L-2009-085
10 CFR 50.54(f)

Florida Power & Light Company
St. Lucie Unit 2
Docket No. 50-389

Subject: Response to NRC Request for Additional Information

**Individual Responses to NRC RAIs for FPL Generic Letter GL 2004-02
Supplemental Responses, Dated 02/27/2008 and 06/30/2008**

Figure 16-1 Note that a portal at azimuth 180 has been omitted

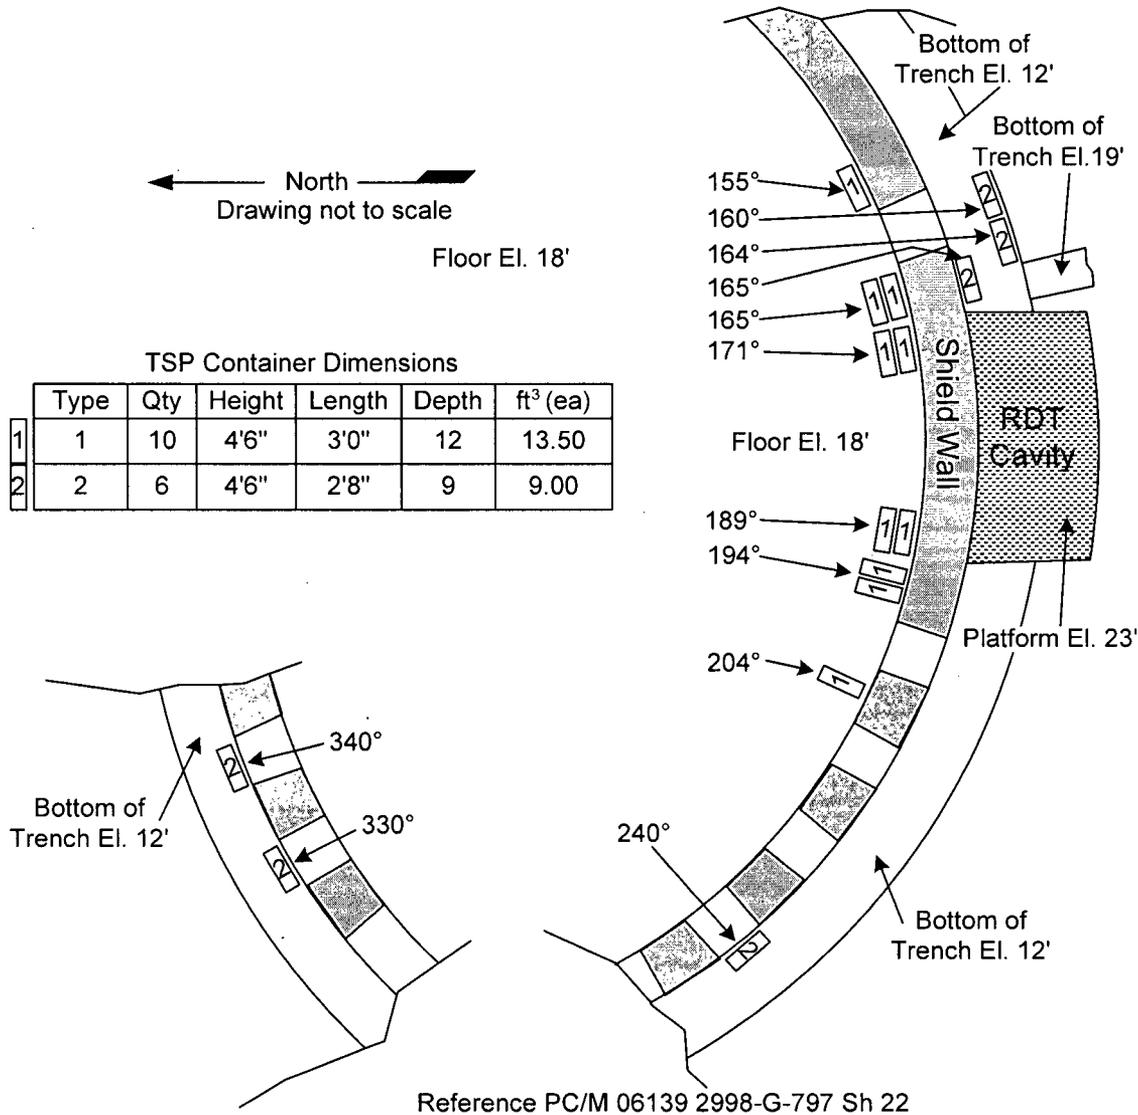
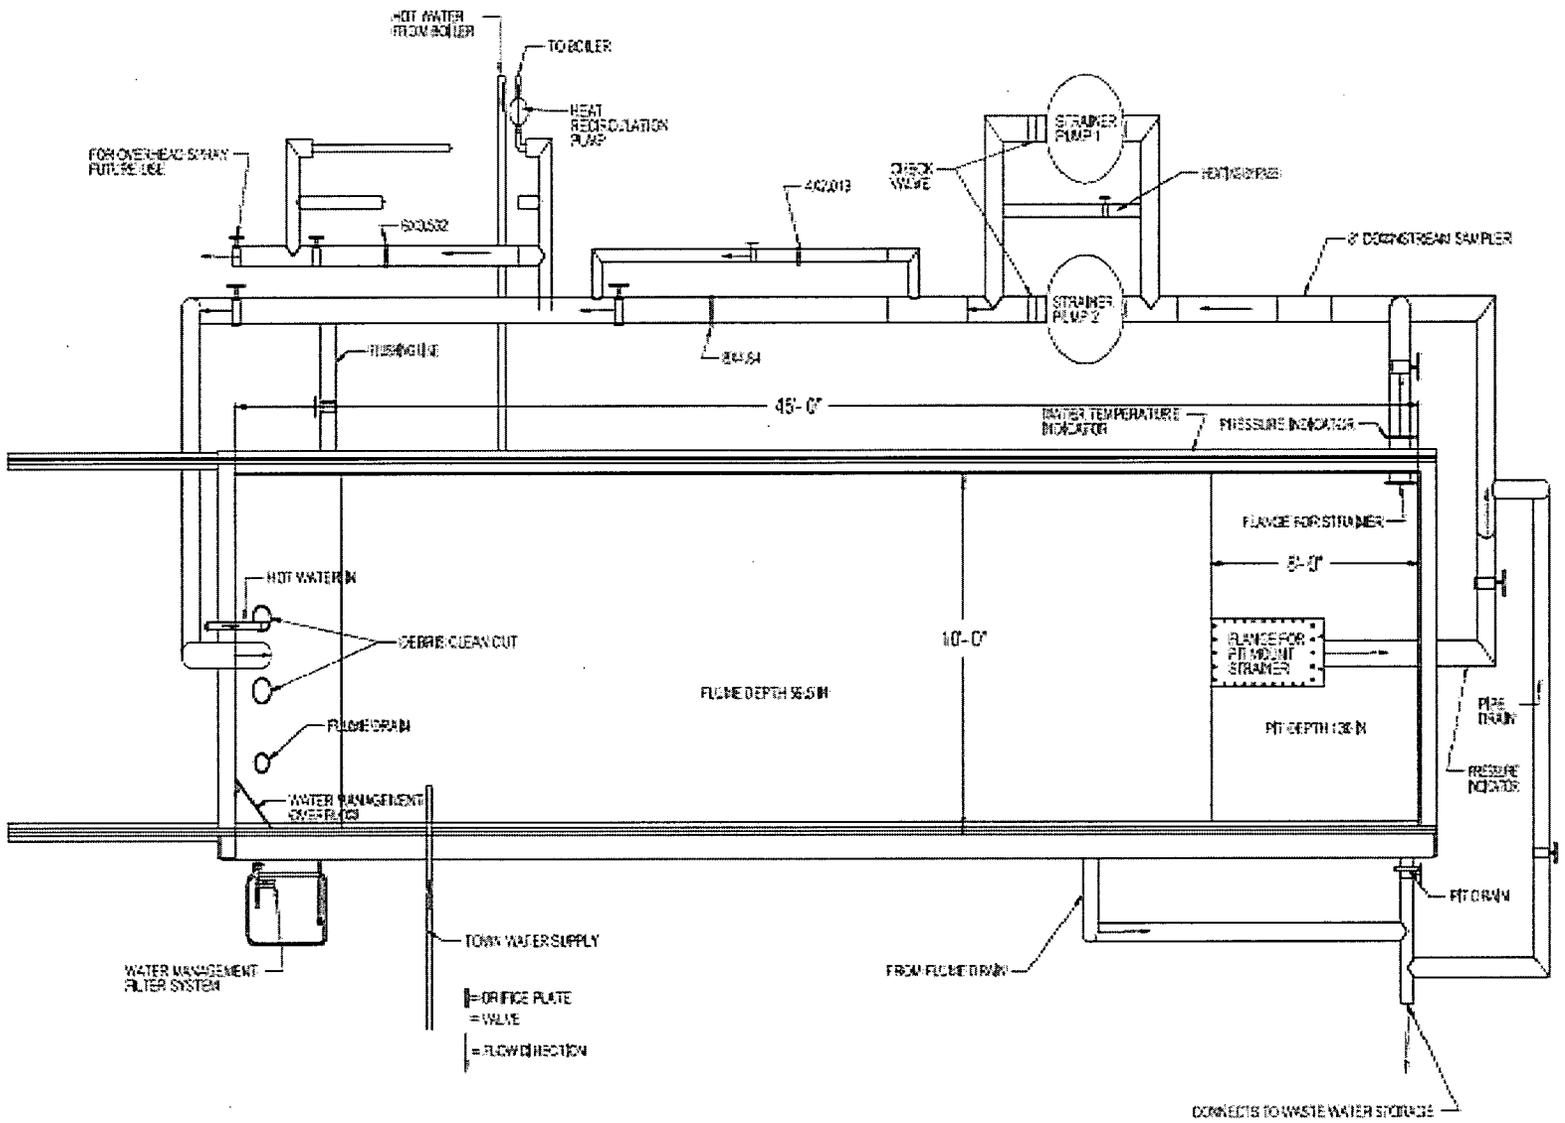
RAI-16: Your submittal indicates that the trisodium phosphate (TSP) is stored in sixteen open baskets in the vicinity of the containment sump. Discuss the distance from the various TSP baskets to the sump strainer relative to the distance in the Alden flume from the chemical precipitate addition point to the test strainer. Given the more rapid settling characteristics for calcium phosphate precipitate, justify why the transport of calcium phosphate in the test flume is conservative relative to the plant. The staff notes that there is uncertainty concerning where calcium phosphate would form as both calcium silicate insulation fines and TSP will dissolve in the post-LOCA pool.

RAI-16 RESPONSE: The St. Lucie Unit 2 TSP containers are of two sizes, type 1 and type 2, and are arranged both within and outside of SBS wall (see Figure 16-1). Ten 13.5 cubic foot containers are within the SBS wall and six 9 cubic foot containers are outside the wall and located inside the ECCS trench at various distances from the ECCS/CSS strainers. The six smaller containers were relocated from the sump pit (reactor drain tank (RDT) cavity) to make room for the new strainers. Thus, the majority of the TSP volume is on the opposite side of the SBS wall from the ECCS/CSS strainers and requires significant approach and flow direction changes to reach the strainers.

The test apparatus consisted of a steel flume measuring 10' wide, 5' deep (with a 6' deep pit) and 45' long (see figure 16-2). Inside of the steel flume, plywood was used to contour the flume walls to simulate the containment approach velocities. The upstream most portion of the flume was used to introduce the flow into the flume resulting in a 35.46' test section. The introduction of chemicals and debris is in accordance with the agreed upon protocols by the NRC, at the drop zone. If the calcium phosphate partially settles in the flume, then it will settle in the

Figure 22b-1: Generic Test Flume Configuration (Top View)

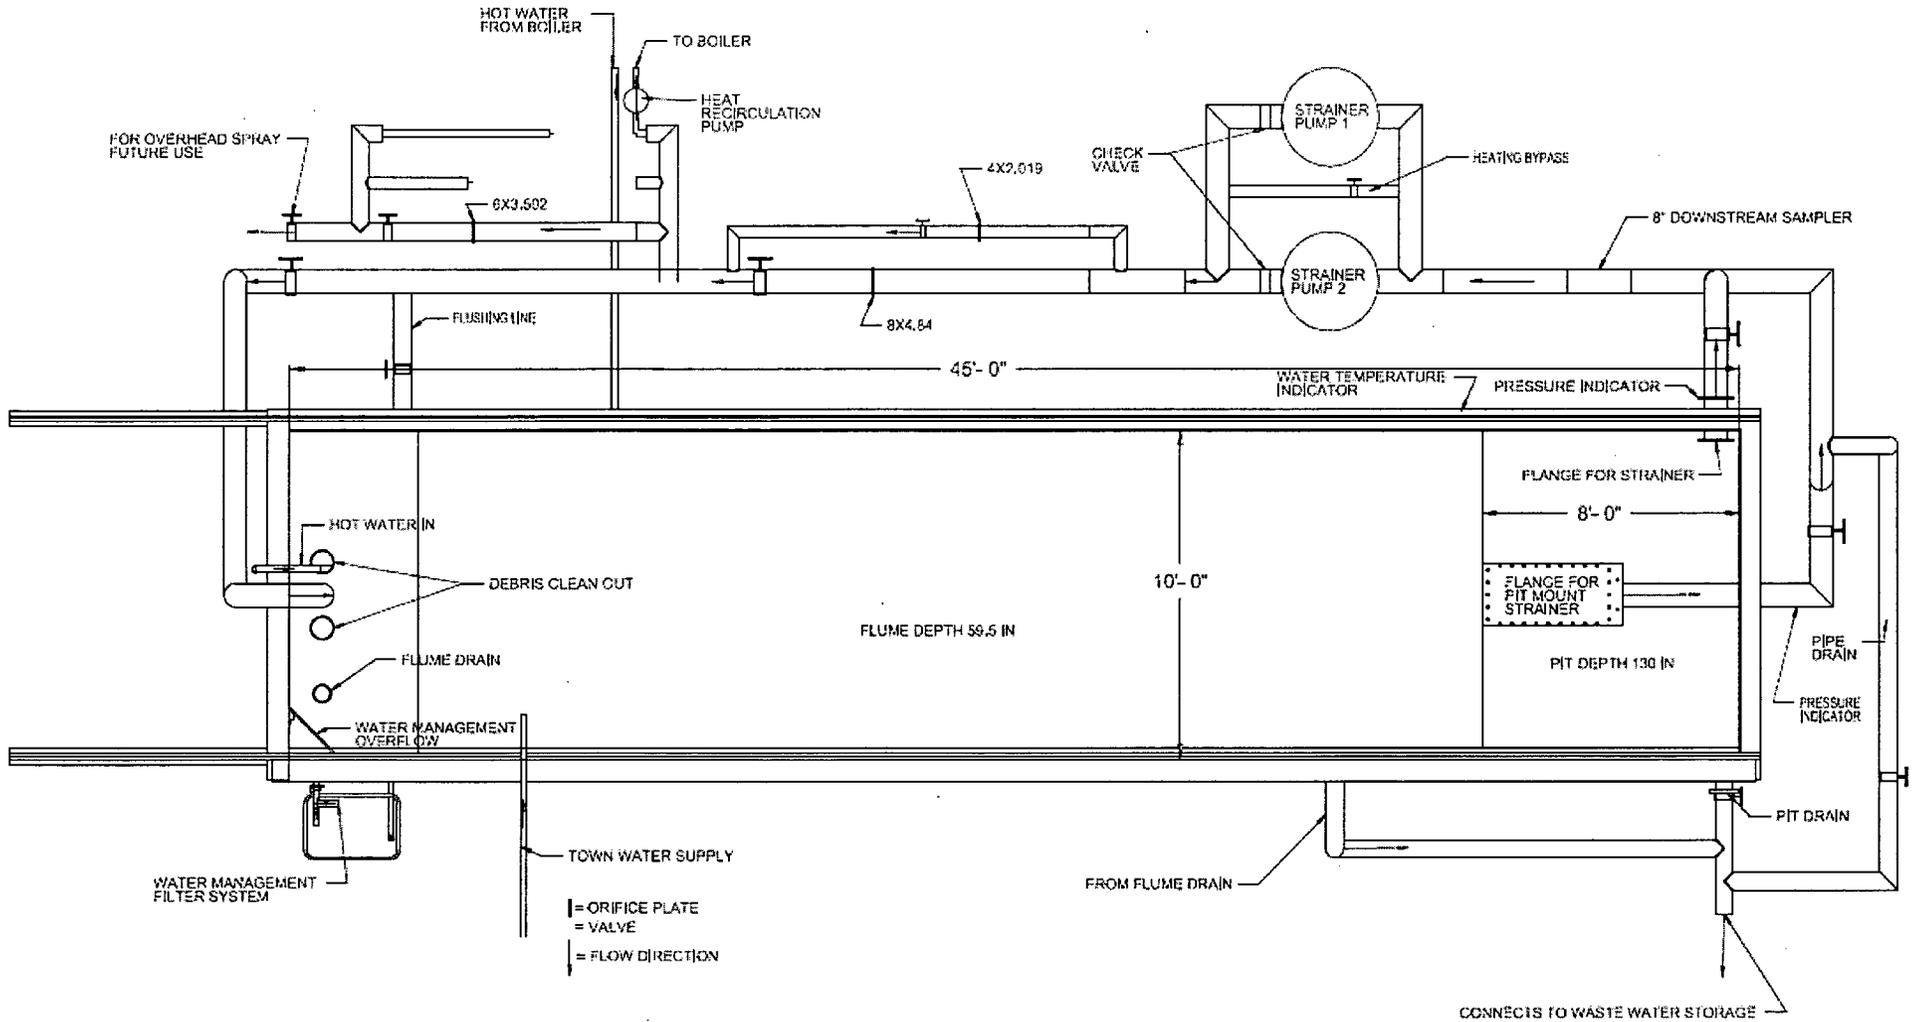
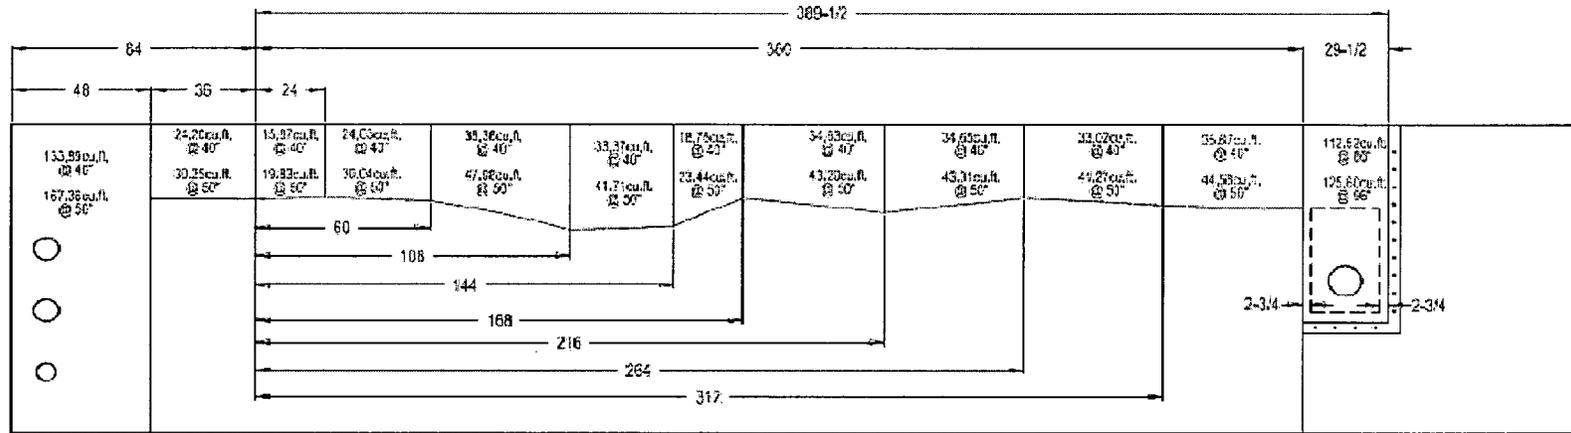
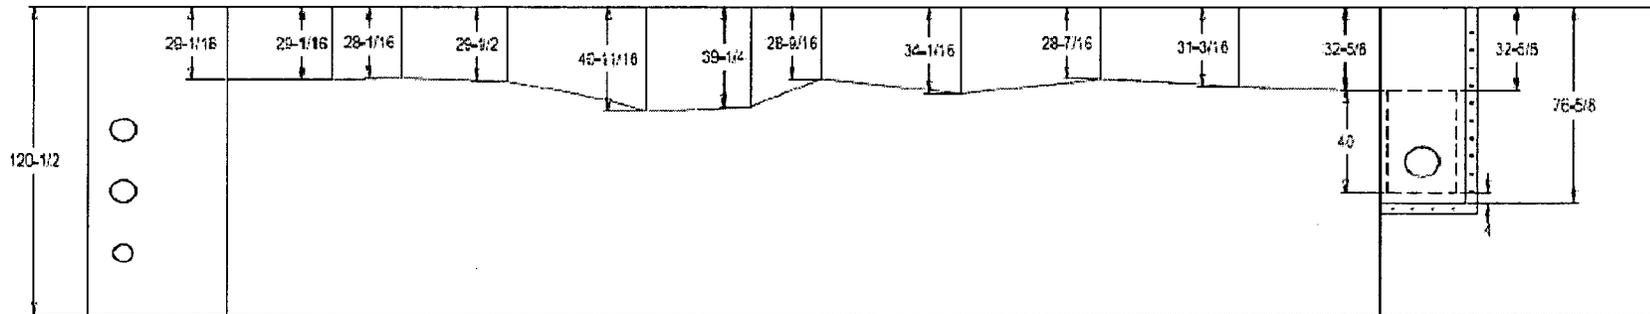
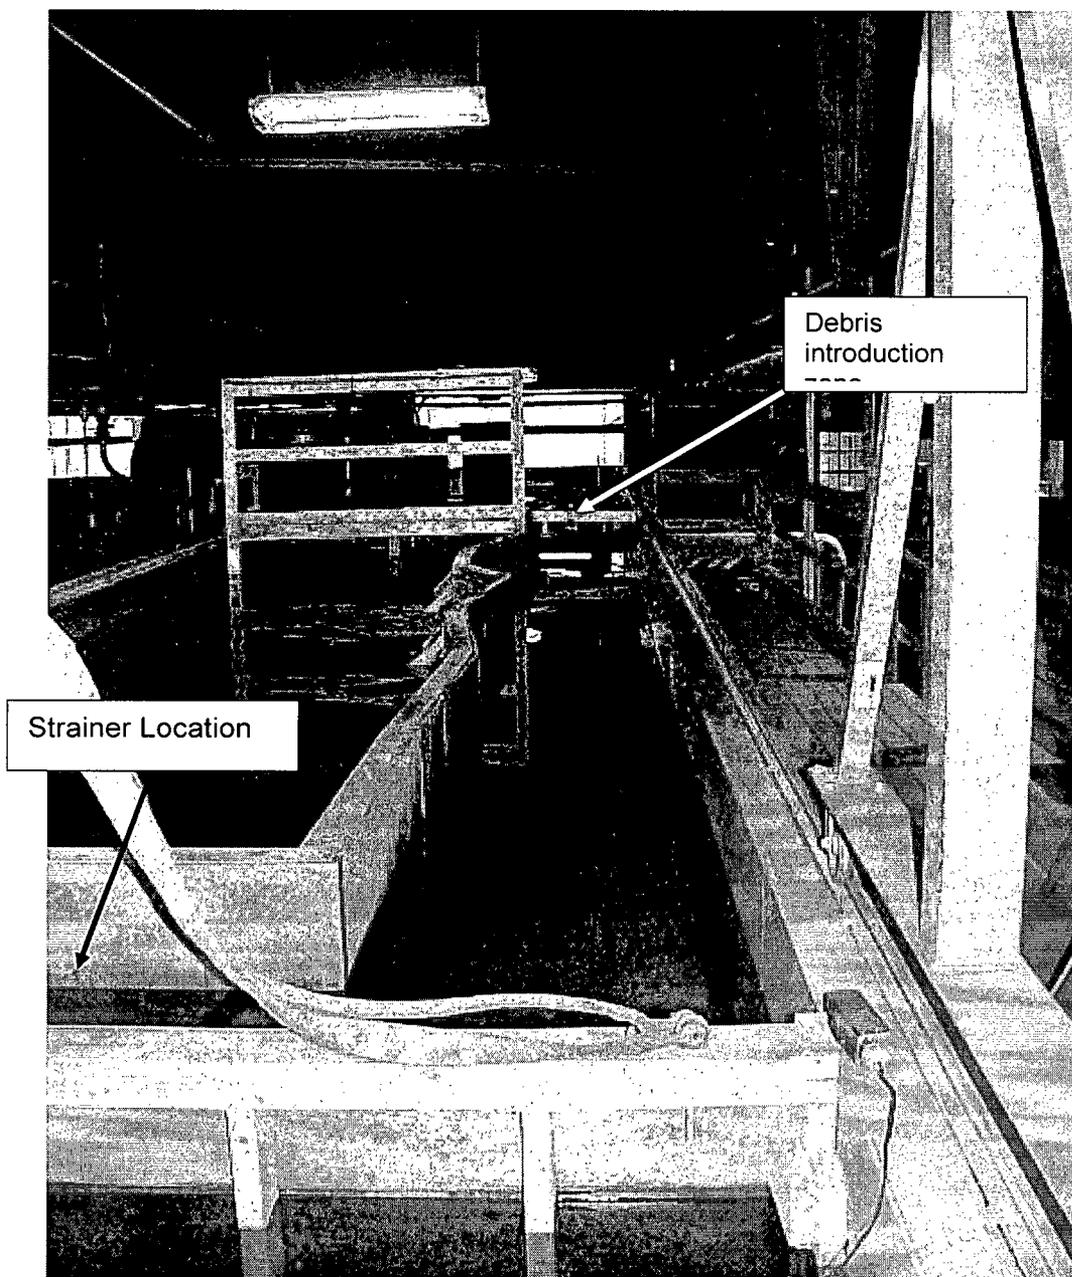
Provide documentation of the head loss testing methodology, including;
Description of test facility.

The test apparatus includes a test flume, two pumps (a main operating pump and a back up pump if the main pump fails. Both pumps do not operate in parallel), a prototype strainer, instrumentation & controls, and the associated piping and valves needed to complete a recirculation loop. The chemical injection system consists of; chemical mixing tanks, a peristaltic pump designated to pump the chemical debris into the test flume, and associated piping/tubing. To conservatively maintain a steady water level at or below the submergence water level during testing, an over flow weir (water management overflow Figure 22b-1) was installed at the upstream end of the test flume. Debris which may have transported past the overflow weir was captured by 5 and 10 micron bag filters located downstream of the overflow weir.

Figures 22b-1 through 22b-3 below depicted the test configuration utilized for St. Lucie Unit 2.

Widthwise Dimensions
 Figure 22d-1: Flume Configuration.

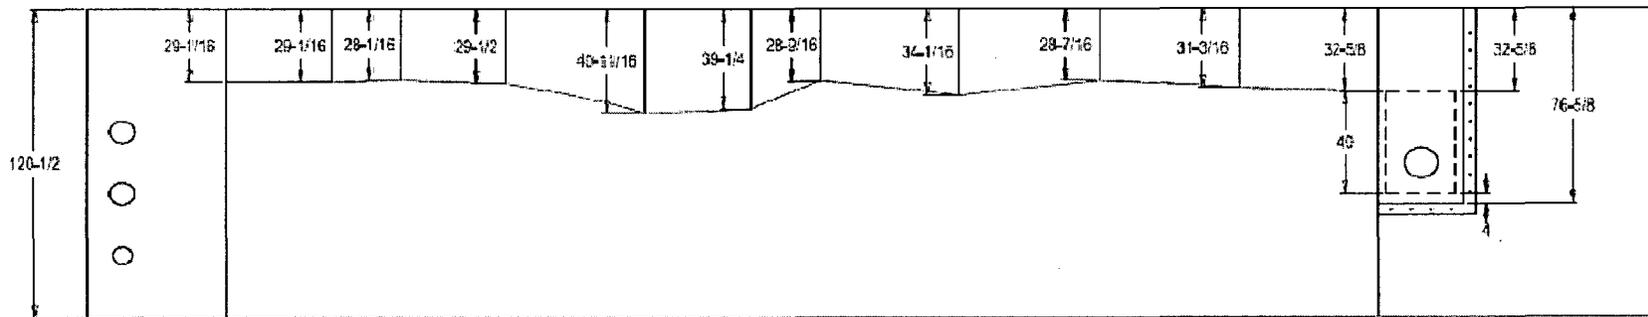
RAI-22d: Provide documentation of the head loss testing methodology, including;
Debris introduction zones.

Batch 1, 25% latent fiber, was introduced along the length of the test flume. All other debris batches, were introduced into the test flume at the drop zone. See Figure 22d-1, below. The introduction zone was 389-1/2" inches upstream of the strainer module. The chemical debris was also introduced to the flume at the introduction zone indicated on Figure 22d-1 below.

Figure 23-1: Close up of Debris Laden Strainer

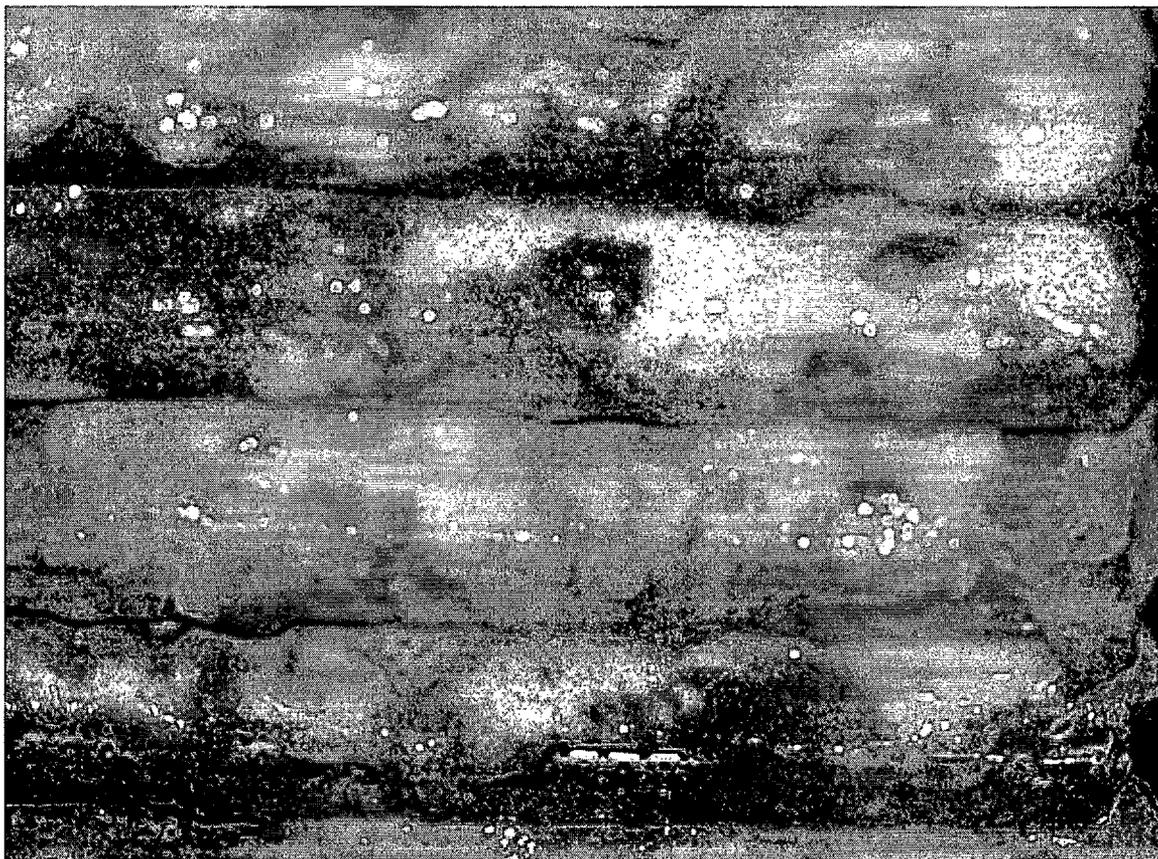
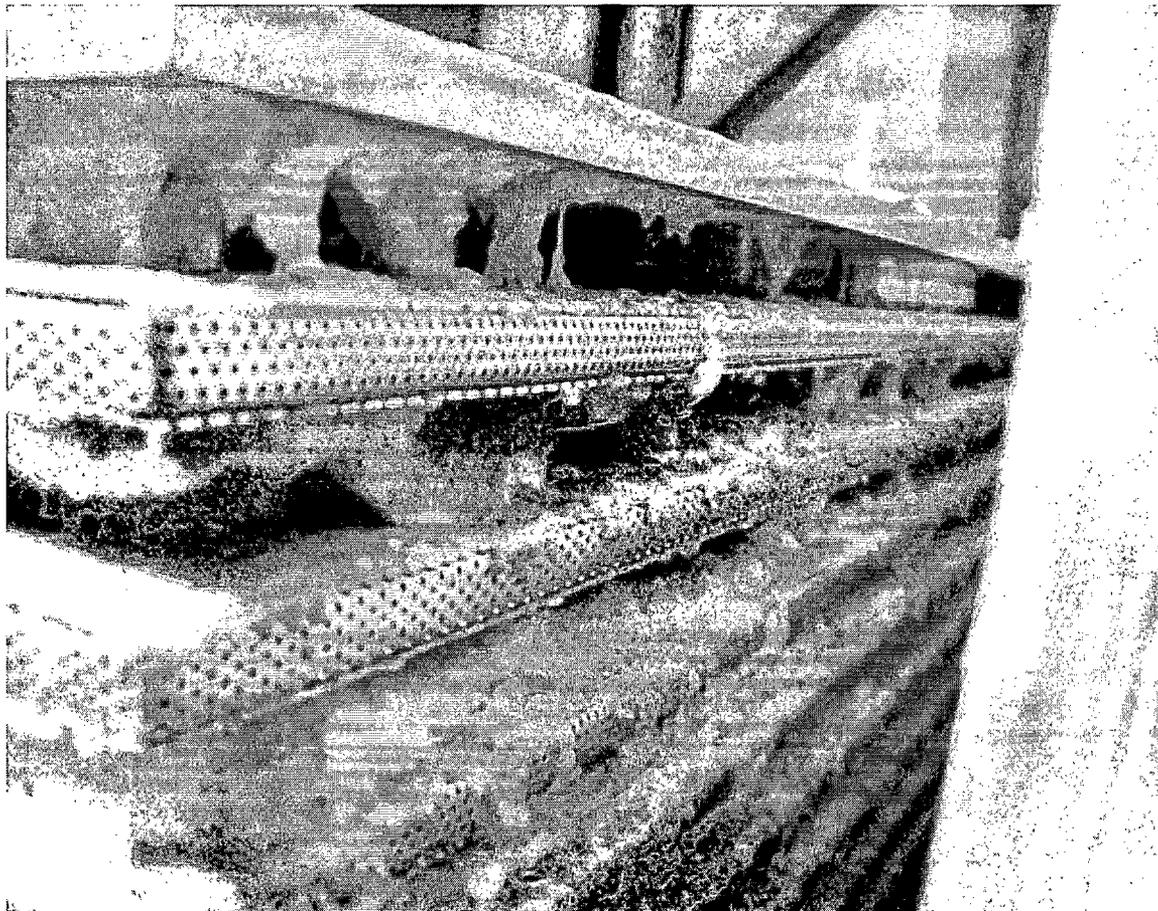
RAI-23: Provide the details of both the methodology and results for the thin bed search tests that were conducted. Include the incremental amounts of fibrous debris added along with the number of flume turnovers between additions.

RAI-23 RESPONSE: For St. Lucie Unit 2 thin bed testing was not performed based on the performance of the design basis test. It was concluded after the design basis debris loaded strainer test that open strainer surface was observed. Therefore, a thin bed had not formed when subjected to the full debris load. Figure 23-1 below documents the strainer surface area observed after the design basis test was complete.

Fiber bypass testing was conducted in accordance with the St. Lucie Unit 2 Strainer Test Plan. Fiber bypass testing placed the same amount and types of fibrous debris in the flume as the design basis test (reference 3, attachment 1, test 1B and test 2). While this test was not designed to create a 0.125" thin bed it demonstrates the 100% fiber load does not create a thin bed and results in clean strainer area as documented in figure 23-2 below.
